DRAIN EXTENSION ON DIFFUSER Prevost vehicles

On the vehicles affected by this bulletin, the end of the exhaust diffuser drain tube may not be properly attached.

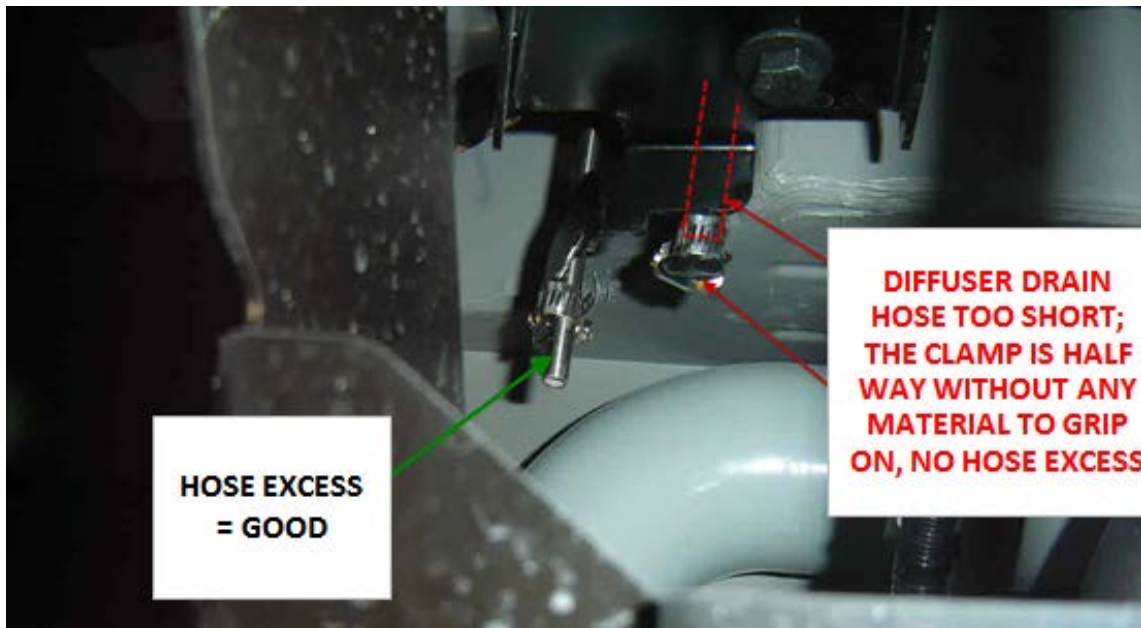
- 1) In the engine compartment, inspect the lower part of the diffuser and make sure there is an excess length allowing proper seating of the clamp.
- 2) If it is not the case, unscrew the clamp to free the tube.

- 3) Add adapter #5011119 to the upper connexion.
- 4) Re-tighten lower clamp.
